ADDENDUM NO.: 3

DATE OF ADDENDUM: 10/30/14

**Utility and Infrastructure Improvements
Camp Hartell
Windsor Locks, CT
BI – Q – 662**

① PRECAST CATCH BASIN - TYPE "C" OR "C-L"

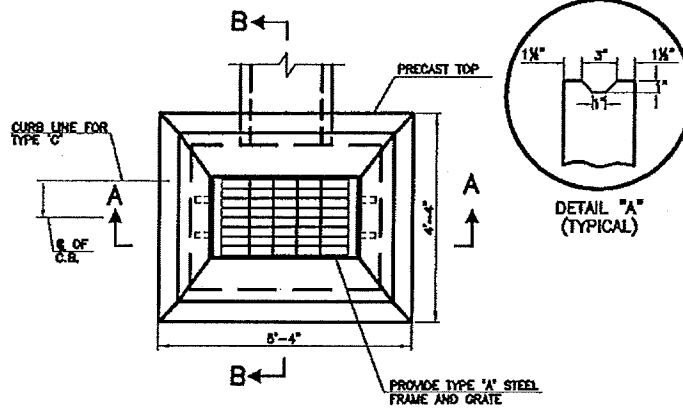
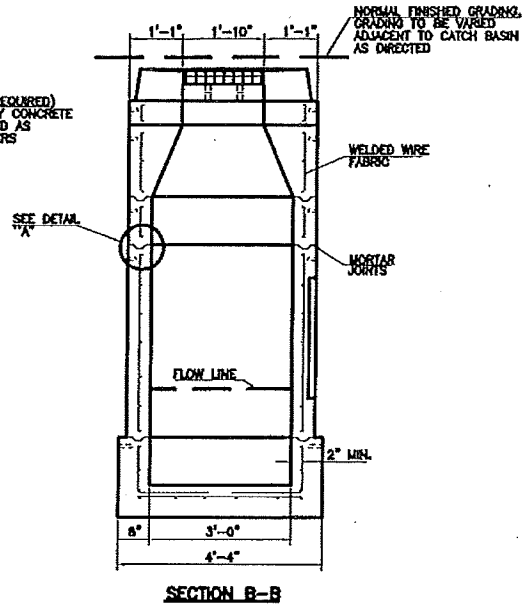
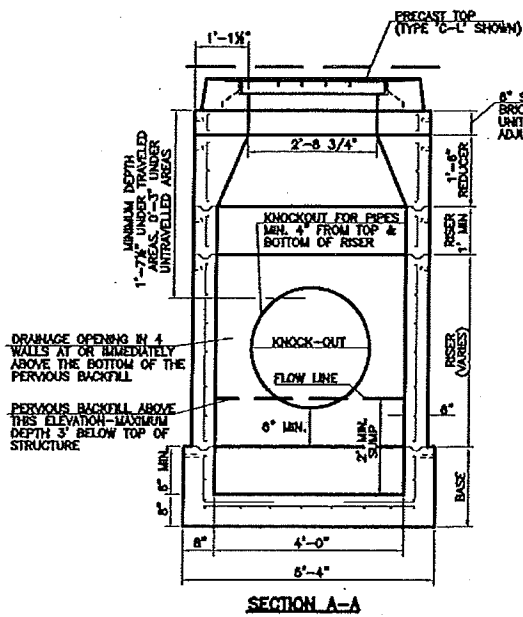
ADD: See 8.5" x 11" attachments for standard catch basin and HDPE details.

1. WHERE A PRECAST CONCRETE UNIT IS USED FOR THE SUMP, THE TOP FOR THE UNIT SHALL BE AT LEAST 6" BELOW THE BOTTOM OF THE PIPE OUTLETTING FROM THE CATCH BASIN.
2. FOR DETAILS OF FRAMES AND GRATES, SEE CONN. DOT STANDARD SHEET 507-K.
3. THE WALLS OF ALL CATCH BASINS OVER 10 FT. DEEP TO BE INCREASED TO 12" THICKNESS, WHILE INSIDE DIMENSIONS TO REMAIN THE SAME.
